MONTGOMERY COUNTY PLANNING BOARD

MEMORANDUM

SUBJECT: **DEVELOPMENT PLAN AMENDMENT No. 09-1:** Fairland Community (Fairland Development, LLC and Fairland Development II, LLC) – an amendment to the approved development plan associated with G-813 & G-814

STAFF RECOMMENDATION: Approve Development Plan Amendment No. 09-1 to create three Amended Development Plans: G-813 Part I and G-814; G-813 Part II; and G-813 Part III in order to remove the golf course component and previously anticipated land exchanges with Montgomery County from the proposed development. The amended development plan has many features to support its approval. It satisfies the land use, environmental protection, and dwelling unit objectives of the 1997 Fairland Master Plan. The plan proposes a total of 365 units, with 46 MPDUs dispersed throughout the development, the dedication of an elementary school site, road connections and extensions, trails and paths providing access to Fairland Recreational Park, open space, a community recreation center with pool and clubhouse, and significant preservation of environmental areas.

ATTACHMENT 8

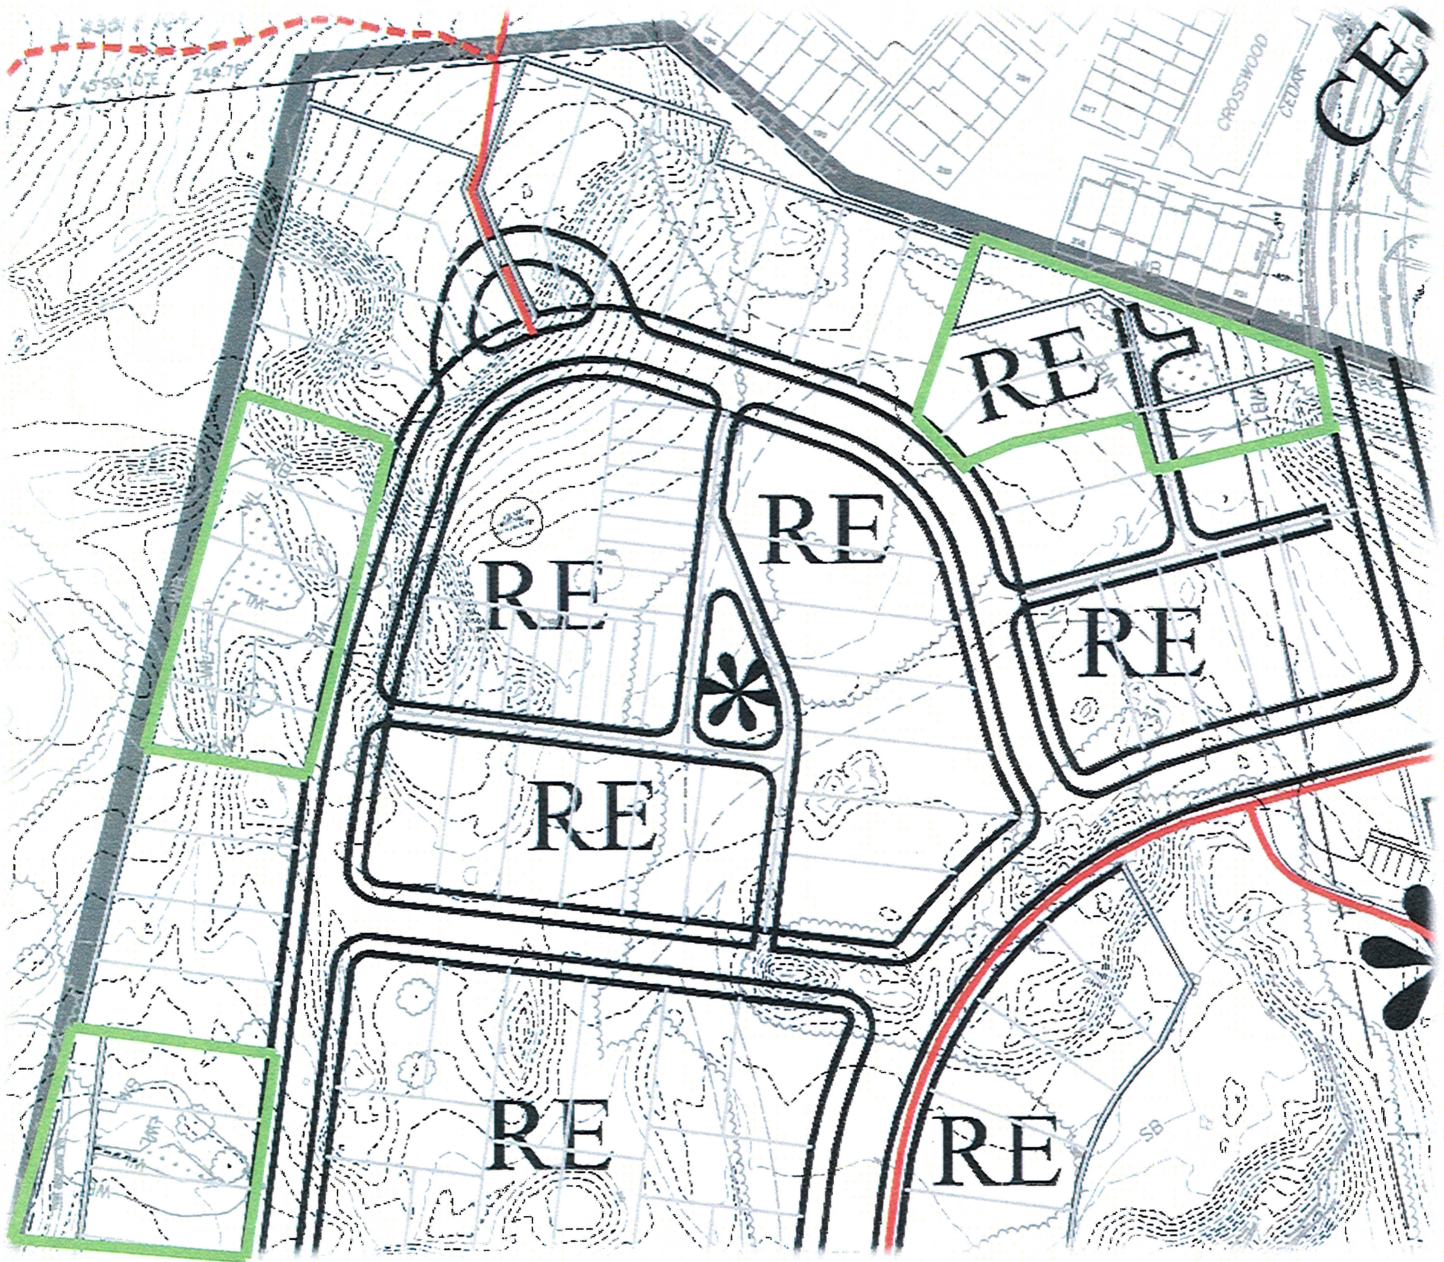
Approximately 11 lots shown on the plan have either wetlands or wetland buffer areas located entirely within or partially on the proposed lots. The wetland areas are shown as buildable lots. The wetland areas are generally located along the boundaries between G-813 Part I and G-813 Part III (Gunpowder Golf Course) and on the western edge of G-813 Part I, nearest to Cedar Lane. (See Circle Pg10.) These wetlands may have been an outgrowth or remnant of the previous sand and gravel extraction operations. The applicant believes that the Maryland Department of the Environment (MDE) should make the ultimate determination of the viability and sustainability of these wetlands, which would, in turn determine whether or not these eleven lots can be built upon. This evaluation, however, will not be completed prior to preliminary plan stage, when Environmental Planning staff will performing a required assessment of these wetlands areas. If these wetlands are determined to be suitable for protection the development must preserve the both wetlands and their buffers in a natural condition. The number of lots proposed on this development plan could, therefore, be further reduced at the time of preliminary plan.

Although the amended development plan satisfies the environmental protection objectives of the master plan, six proposed lots and portions of five additional lots may be affected by wetlands and their buffers. An environmental assessment of the wetlands areas to determine their sustainability will have to be made at preliminary plan stage. If the wetlands are determined to be suitable for protection, it may mean fewer lots than now proposed.

- 1) At the time of preliminary plan review, Environmental staff should conduct an assessment of the wetland areas. If they are deemed suitable for protection by the time of preliminary plan stage, the proposed development should preserve the wetlands and their buffers in a natural condition.
